Engineering Design Standard Section 6-3

ADDENDUM TO BUCKEYE PAVING DESIGN STANDARDS

Request No. 1	APPROVED: Y / N	ADDENDUM NUMBER <u>SP -2</u>
---------------	-----------------	------------------------------

Revised Text/Detail: Modified MAG Standard Detail 221

MODIFIED MAG STD DET 221 INTEGRAL ROLL CURB, GUTTER AND SIDEWALK

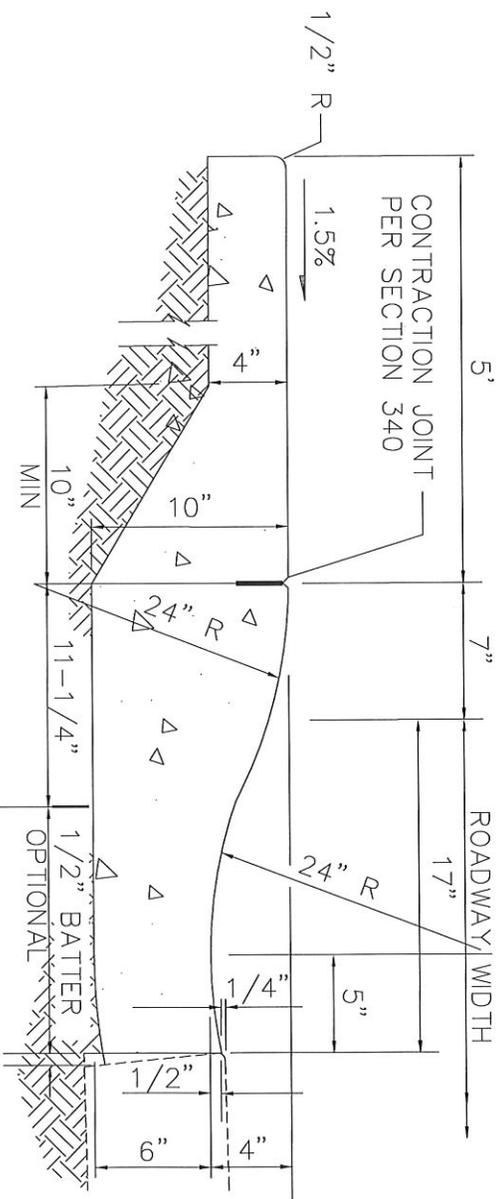
Buckeye is revising the MAG detail 221 "Integral Roll Curb Gutter and Sidewalk" for internal use. The revision changes the transition length and thickness between the back of the curb section and the sidewalk.
